Braidwood Station, Units 1 and 2
Facility Operating License Nos. NPF-72 and NPF-77
NRC Docket Nos. STN 50-456 and STN 50-457

Byron Station, Units 1 and 2
Facility Operating License Nos. NPF-37 and NPF-66
NRC Docket Nos. STN 50-454 and STN 50-455

Subject: Response to NRC Requests for Additional Information, Set 4, dated December 12, 2013, related to the Braidwood Station, Units 1 and 2, and Byron Station, Units 1 and 2 License Renewal Application

**Byron and Braidwood Stations (BBS), Units 1 and 2
License Renewal Application
Responses to Requests for Additional Information**

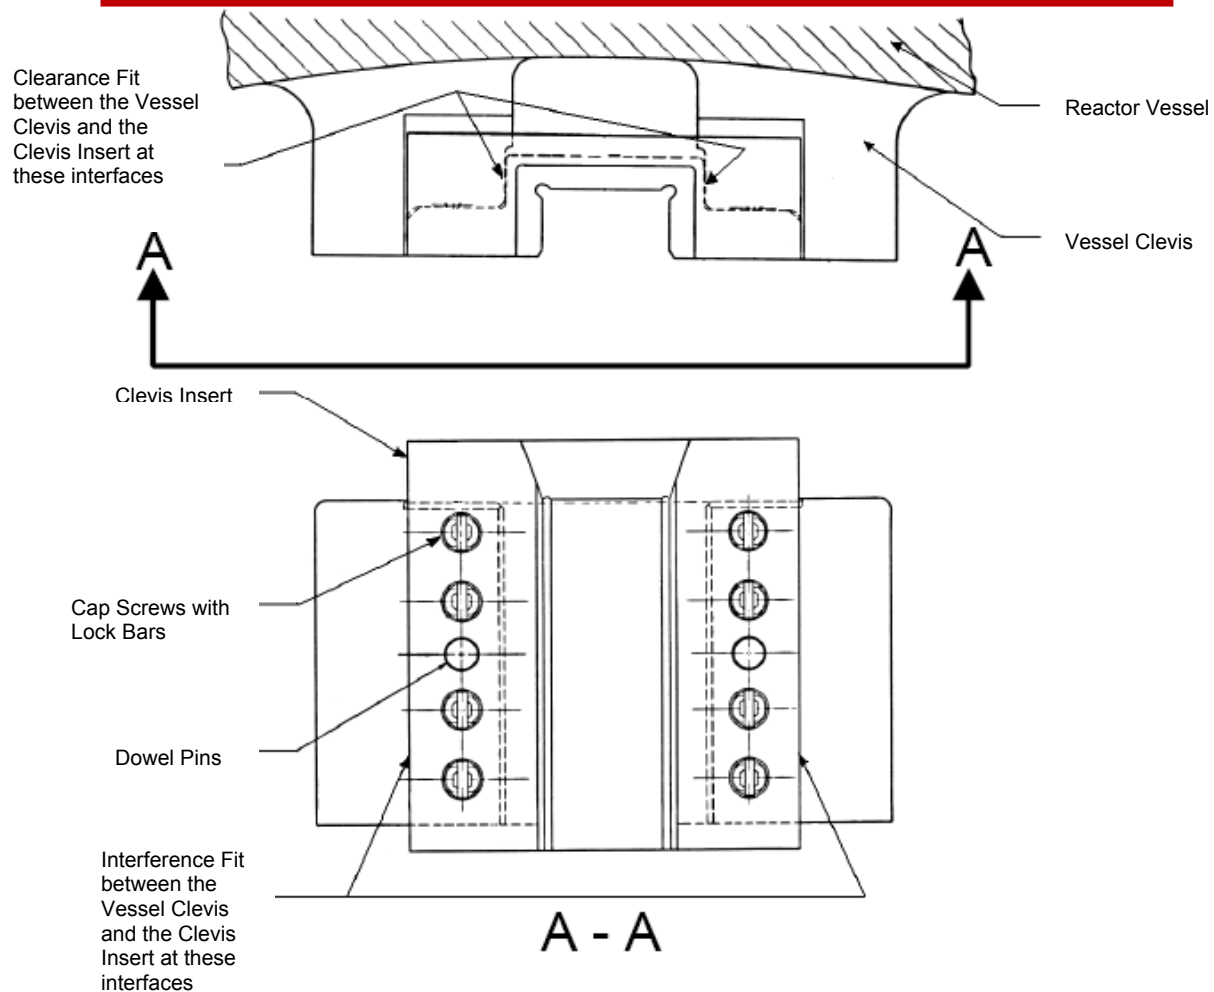
1. Specify the fabrication material, including any applicable heat treatment, for the clevis insert bolts at Byron and Braidwood, Units 1 and 2.
2. Discuss and justify whether the operating experience associated with cracking of the clevis insert bolts (discussed above) is applicable to Byron and Braidwood Stations, Units 1 and 2.
 - o If applicable, discuss and justify how your PWR Vessel Internals Program will be augmented to require an inspection of the clevis insert bolts capable of detecting cracking. If the PWR Vessel Internals Program will not be augmented, provide a technical justification for the adequacy of the existing VT-3 visual inspection to detect cracking before it results in clevis insert bolt failure.

- Precipitation hardened at $1350 \pm 15^\circ\text{F}$ ($732 \pm 8^\circ\text{C}$), hold for 8 hours, furnace cool to $1150 \pm 15^\circ\text{F}$ ($621 \pm 8^\circ\text{C}$), hold until total precipitation heat treatment has reached 18 hours, air cool.

This heat treatment is similar to that which is typically referred to as low-temperature annealed and aged condition (BH).
